TO: Mayor Andrew Dickens, City of Atlanta
ATTN TO: Steven Aceto, Urban Planner, City of Atlanta
RE: Development of Regional Impact Review
FROM: Mike Alexander, COO, Atlanta Regional Commission

Name of Proposal: 680 Spring Street DRI 4321

Description: A DRI review of a proposal to construct a mixed-use tower with 626 units and 8,616 SF of retail space on a previously developed 2-acre site at 680 Spring Street in Midtown Atlanta in Fulton County.

SHEET NUMBER:
SAP1.0
ISSUED FOR CONSTRUCTION

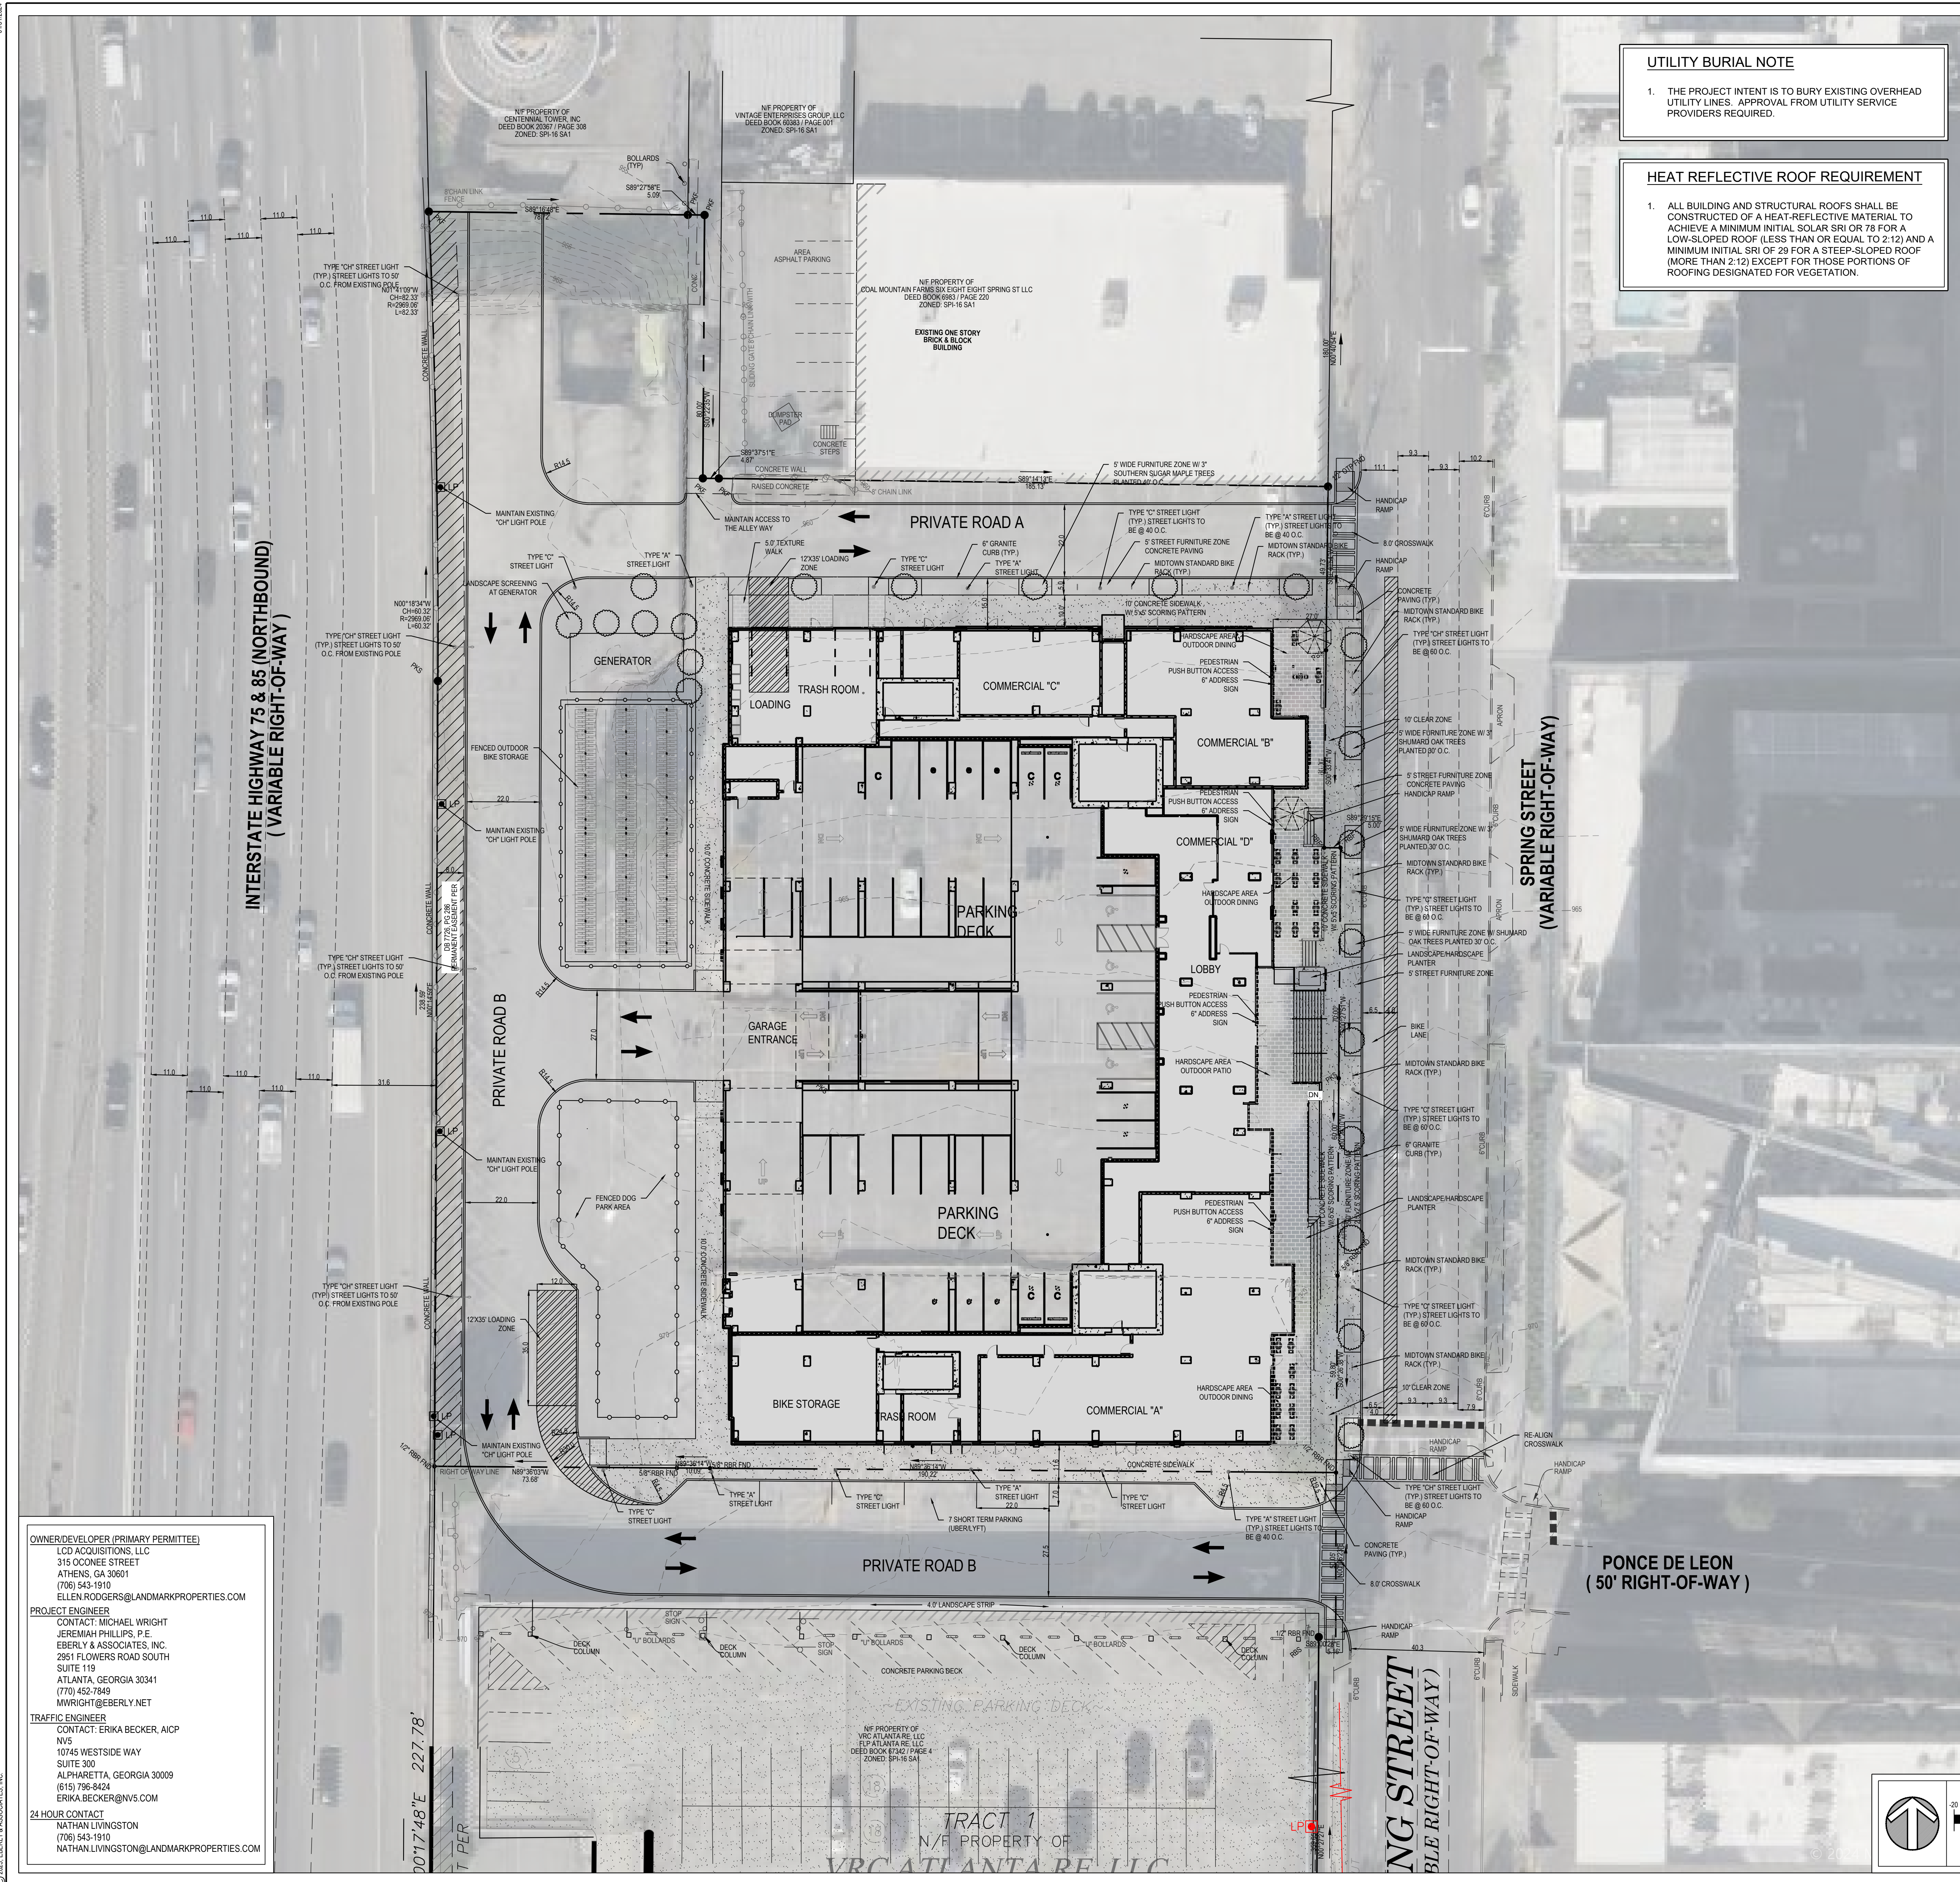
Consideration should be given to accommodating a future connection from the Varsity property to the south to the southern most driveway running from Spring Street to the western edge of the project so that the pedestrian experience from the project south to North Avenue can be dramatically improved.

Consideration should be given to accommodating a future connection from the Varsity property to the south to the southern most driveway running from Spring Street to the western edge of the project so that the pedestrian experience from the project south to North Avenue can be dramatically improved.

Care should be taken to ensure that the constructed development provides an interconnected, functional, clearly marked, and comfortable pedestrian experience on all driveways, paths, entrances, and parking areas. To the maximum extent possible, new driveways and intersection corners where pedestrians will cross should be constructed with minimal curb radii to reduce speeds of turning vehicles and decrease crossing distances for pedestrians.

The project can further support The Atlanta Region's Plan by incorporating other aspects of regional environmental policy, including green infrastructure and/or low-impact design, e.g., pervious pavers, rain

gardens, vegetated swales, etc., in parking areas and site driveways, and as part of any improvements to site frontages.
